Re: K&N Engineering, Inc. Safety Recall

SAFETY RECALL NOTICE

SAFETY RECALL NOTICE

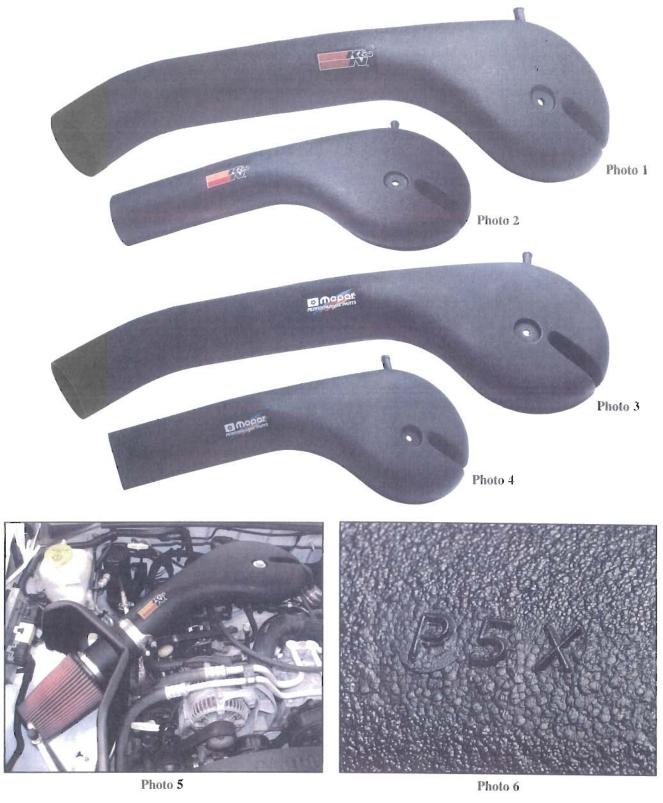
K&N or Mopar Part Number	Associated Vehicle Models and Model Years
57-1 527 (Photo 1)	1994-2001 3.9L Dodge Ram 1500 P/U Truck
57-1511 and 57-1511-1 (Photo 1)	1994-2002 5.2L 1500 & 5.9L Dodge Ram 2500 P/U Truck
57-1509 (Photo 2)	1997-1999 5.2L & 5.9 L Dodge Dakota & Dodge Durango
57-1517 and 57-1517-1 (Photo 2)	2000-2003 5.9L Dodge Dakota & Dodge Durango
57-1 530 (Photo 2)	2002-2003 5.9L Dodge Ram 1500 P/U Truck
Mopar P5007070 (Photo 3)	1994-2002 5.2L 1500 & 5.9L Dodge Ram 2500 P/U Truck
Mopar P5007069 (Photo 4)	1997-1999 5.2L & 5.9 L Dodge Dakota & Dodge Durango

K&N has discovered that the air delivery tubes in the covered kits, which were produced with either polypropylene or super linear polyethylene, have durability problems that can cause pieces of plastic to break away from the tube. Those pieces of plastic could enter the vehicle engine, where they could possibly cause the throttle to become temporarily jammed in the open position. This could potentially lead to a loss of control, which could result in a crash. Therefore, K&N is offering replacement air delivery tubes made with cross linked high density polyethylene, at no charge.

If you have one of the vehicles listed above that have a non-factory air intake system or kit installed, a visual inspection will easily identify whether you have a Kit covered by this recall. The recalled parts have a multi-color trademark printed on the top of the air delivery tube that reads either "K&N" or "Mopar Performance Parts," as shown in the photographs on the next page (See Photo 5).

If the air delivery tube has the "K&N" trademark, you will need to examine it to determine whether it needs to be replaced. On the bottom side of the tube is a set of markings; if you can see a marking P#X (where the # stands for a number), the Kit is <u>not</u> covered by this recall (See Photo 6). All other K&N Kits on the vehicle models specified above <u>are</u> covered by the recall, and you should contact us at (\$00) 858-3333 to obtain a replacement part free of charge.
